IDAP REPORT

Property:	48 Churchill Avenue, Strathfield Lot 40 DP 933113 DA 2021/199
Proposal:	Construction of a secondary dwelling
Applicant:	Pinnacle Designs Solutions
Owner:	Alan and Betty Davidson
Date of lodgement:	9 August 2021
Notification period:	23 August 2021 to 8 September 2021
Submissions received:	One (1)
Assessment officer:	E Black / P Santos
Estimated cost of works:	\$100,000.00
Zoning:	R2-Low Density Residential - SLEP 2012
Heritage:	Heritage Conservation Area - "C10" Churchill Avenue Conservation Area , Federation houses group Adjoins a heritage item – I120 – "Wynella" Federation house
Flood affected:	Yes
RECOMMENDATION OF OFFICER:	APPROVAL

Development consent is being sought for the construction of a secondary dwelling.

Figure 4. Extract of the proposed elevations of the secondary dwelling.

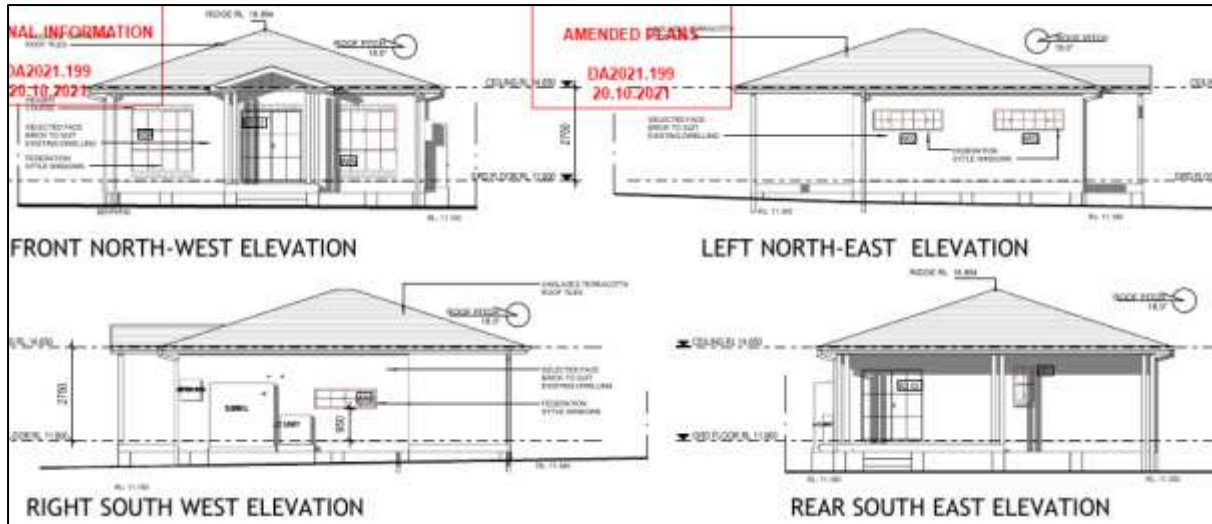
"The secondary dwelling may be viewed via the sight lines. The applicant should change the window style and materials used (including roof and bricks) to match the existing dwelling. This is consistent with the additional controls for Heritage in this area."

The applicant has provided amended architectural plans demonstrating that the roof, windows and bricks of the secondary dwelling are to be consistent with the request of Council's Heritage Advisor. As such, the proposal is supportable subject to conditions of consent.

Figure 7. Extract of the northern elevation with the incorrect RL 18.894 highlighted.

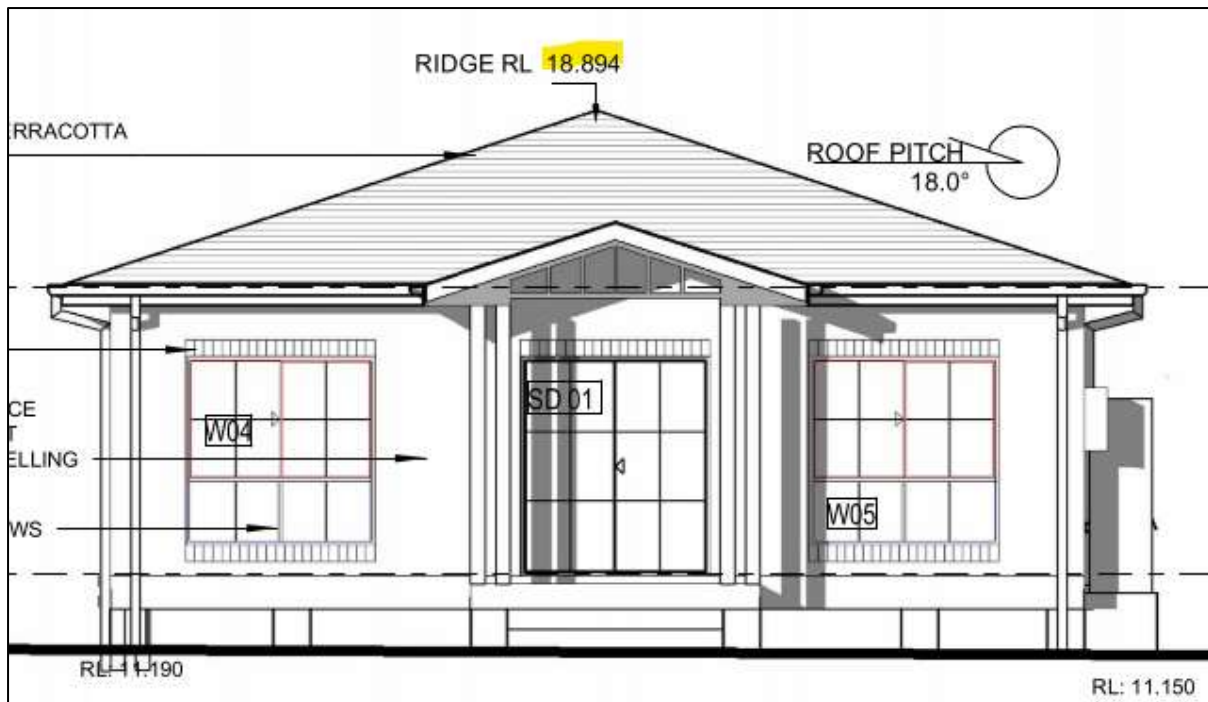
The submitted elevations show an RL of 18.894, which would result to a height of 7.45m. However, this is incorrect as the RL, when measured utilising the scale in the submitted plans, should be RL 16.35. This provides a height of 4.9m. A condition of consent will be imposed to amend the plans and have the RLs on the elevations to reflect RL 16.35.

The height of the building measured from Australian Height Datum (AHD) must not exceed Relative Level (RL) 16.35 AHD to the ridge of the secondary dwelling.

Figure 8. Extract of the initial floor plan submitted showing an alfresco of 28m².

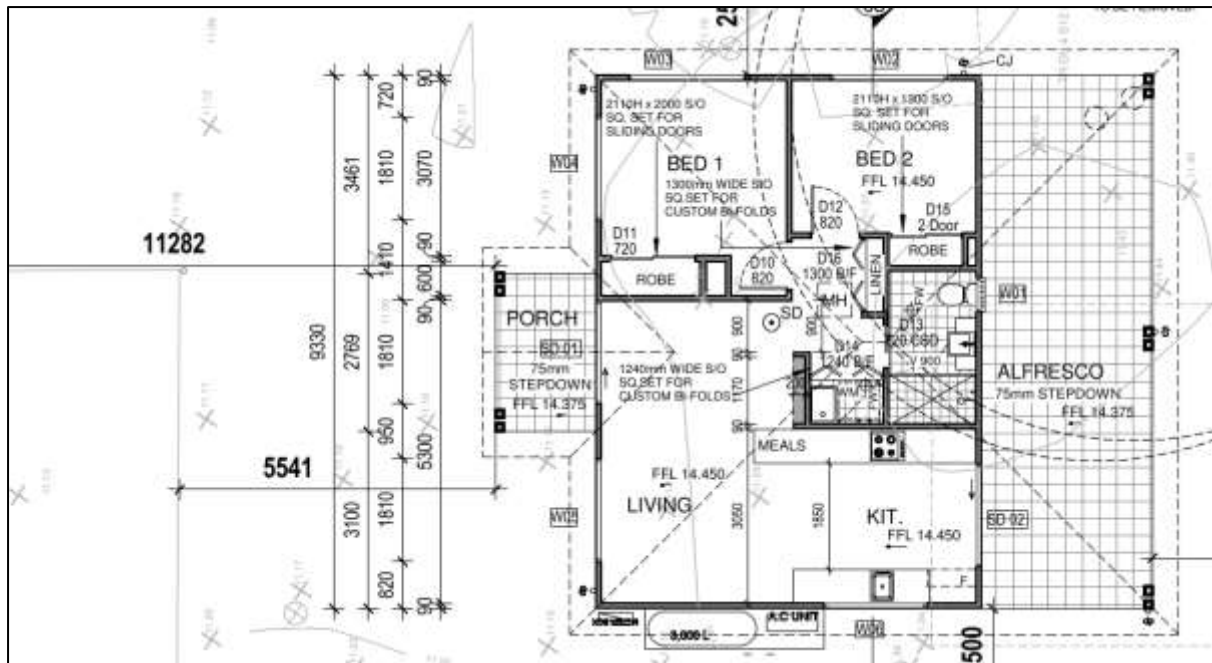
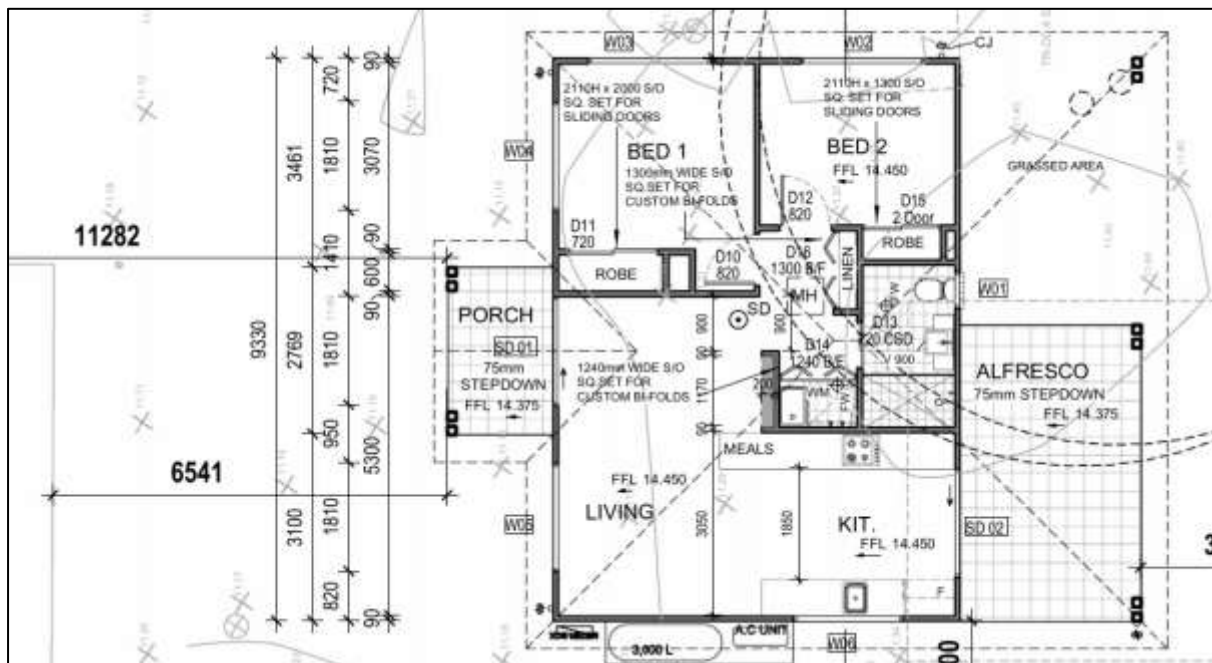
The submitted plans show a landscaped area calculation of 259m². This does not satisfy the requirements of the SCDP 2005 of 41.5% (284.34m²) landscaping to be provided on-site.

The plans were amended to reflect an increased grassed area beside the alfresco. See Figures 8 and 9 below. This area is ineligible to be counted as landscaping due to it being under the roof of the proposed dwelling. The variation of 8.9% (25.34m²) of landscaping from the development control will not be supported.

A condition of consent will be imposed to redesign the roof to have no covering over the new grassed area beside the alfresco. This would result to a landscaping of 40.37% (276.6m²). While this may still present a non-compliance with the development control, the shortfall (7.74m²) is negligible and will have no adverse amenity and environmental impacts.
